Walker Chapel Historic Cemetery

The project is to add a hardscape path from Cole Plaza inside the main gate,

March 21, 2026

PRESENTATION TO THE ARLINGTON COUNTY HALRB
Proposed Relocation of A/C System Condenser Units
WALKER CHAPEL UNITED METHODIST CHURCH
23 APRIL 2026

CONSTRUCTION

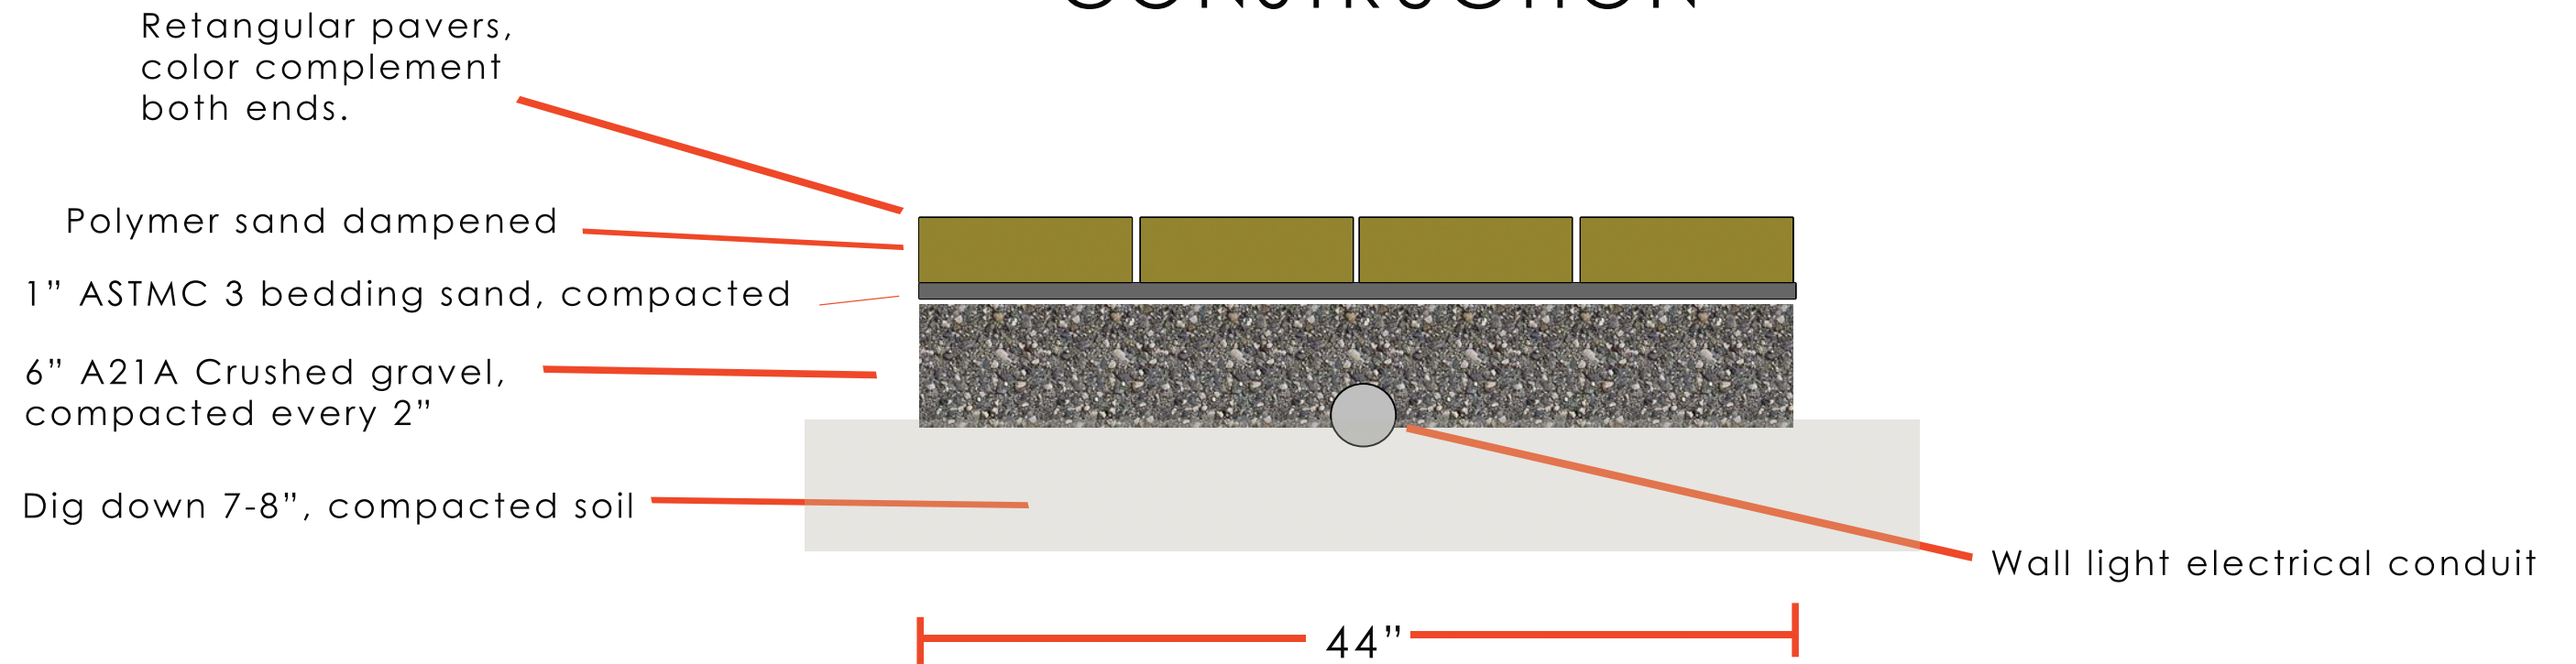
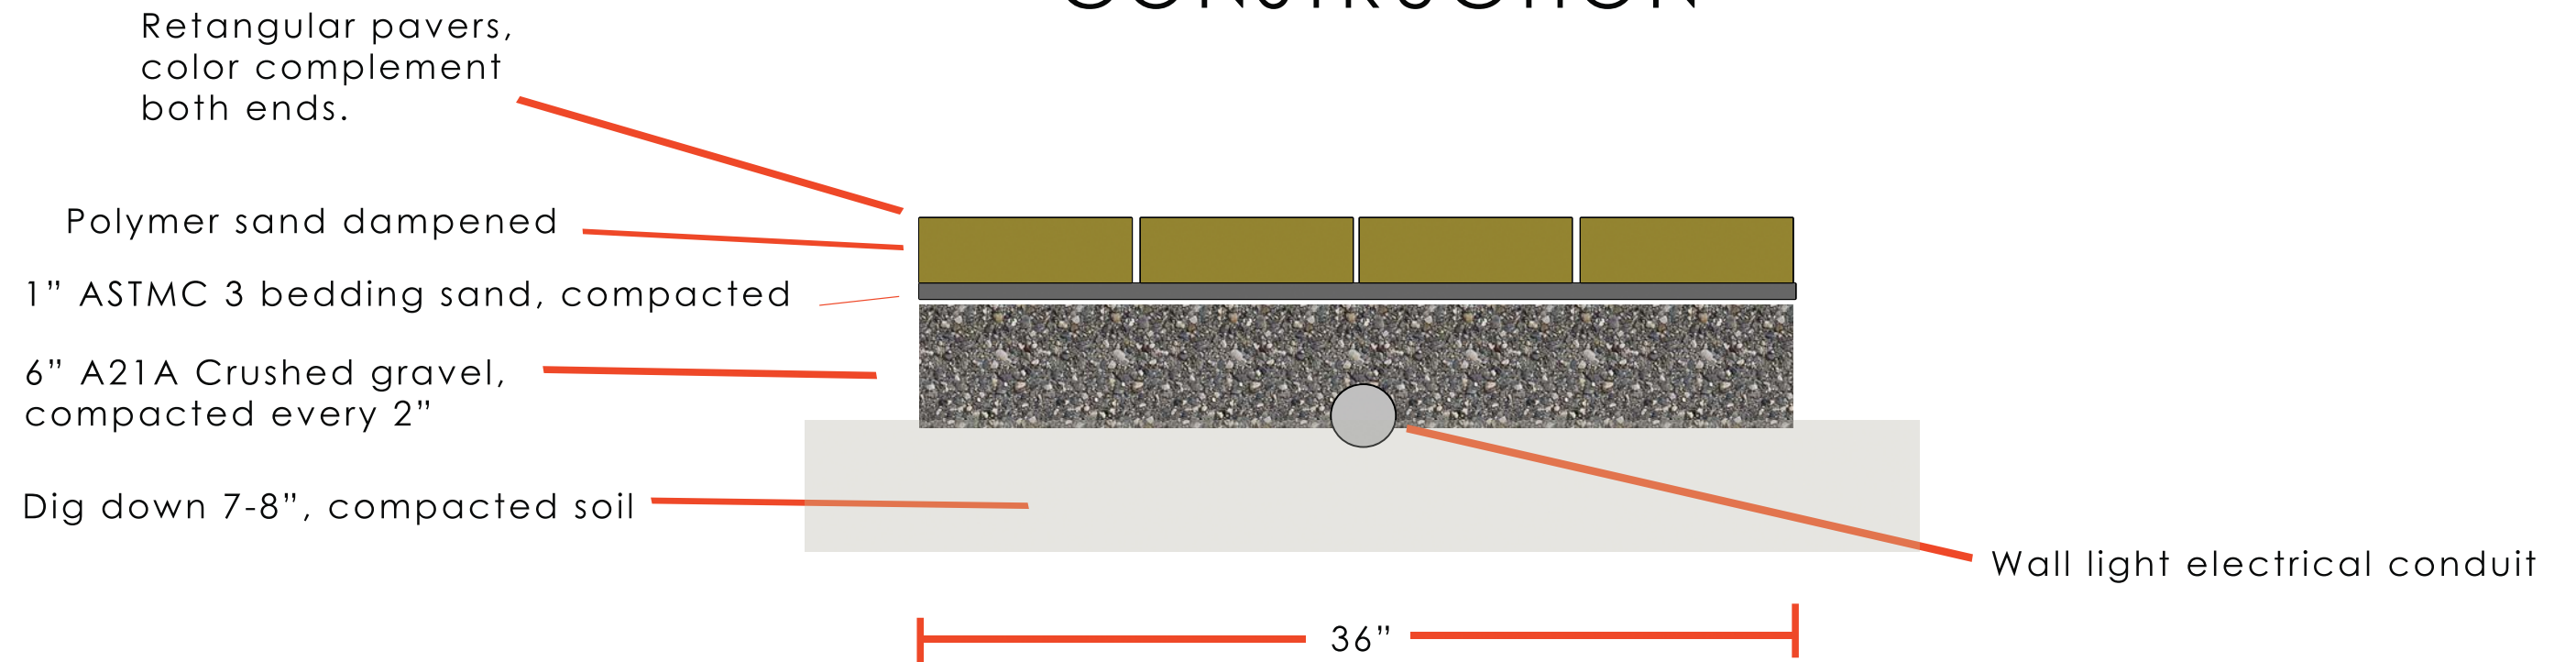
After HALRB approval and as we proceeded to request final approval and funding from the Walker Chapel Leadership Board, the bidding contractors, the Chapel Architect, Funeral Home contacts, and construction documentation raised consensus that the original 36" wide walkway was a problem. The 36" width is sufficient to accommodate the folding cart (called a Church Truck) with casket. But, if the Church Truck with a 22" wheel base started to roll crooked, it might go off edge of the path. On the advice of the group, the width was increased by 8" to 44". The Chapel Leadership Board approved the change and the change is herein submitted to the HALRB for approval.
